**IN RE: REVIEW OF THE PUERTO RICO
ELECTRIC POWER AUTHORITY
INTEGRATED RESOURCE PLAN**

CASE NO.: NEPR-AP-2023-0004

SUBJECT: Motion Submitting Responses to the First Set of 2025 IRP Post Filing Request of Information in Compliance with Resolution and Order of December 3, 2025

Attachment A Responses to First
Set of 2025 IRP Post-filing
Request For Information (RFI)

Figure 1: Example USE File Names

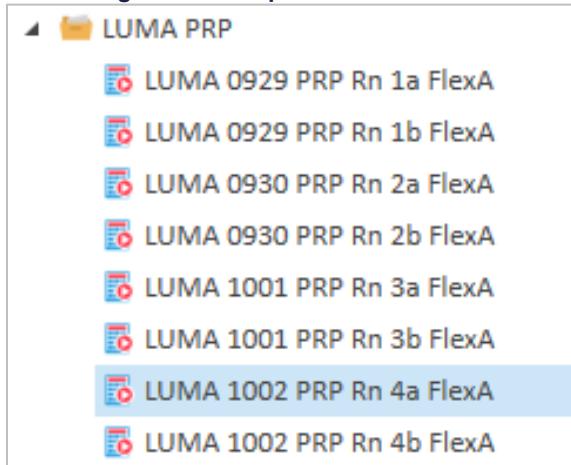
- b. For the files within the "CSV files" subfolder of the "CONFIDENTIAL PLEXOS Model" folder, provide a detailed description of how the filename relates to the specific PLEXOS iteration and how those files map to the "multi-step iterative PLEXOS modeling process " as depicted in Figure 73 of the IRP filing.
- c. Please identify for the files contained within the "CSV files" subfolder of the "CONFIDENTIAL PLEXOS Model" folder that correspond to specific scenario runs and share the same naming convention, which files represent the final versions. For example, indicate whether "LUMA 0930 Sc12 Hourly USE.xlsx" is the final version as compared to "LUMA 0917 Sc12 Hourly USE.xlsx".

- b. See response to question "3a" above.
- c. The final version of the files used in the modeling can be identified through the dates associated with the dates in the PLEXOS® model. For example, the final Unserved Energy (USE) file used in the modeling of the PRP is titled *"LUMA 1001 Sc1 Rn 3b FlexA ASAP Batt Eff Solution Hourly USE"* since the last iteration for this scenario was the next iteration, i.e., 4a and 4b run on 10/02, which resulted in acceptable USE results as shown in Figure 1 below.
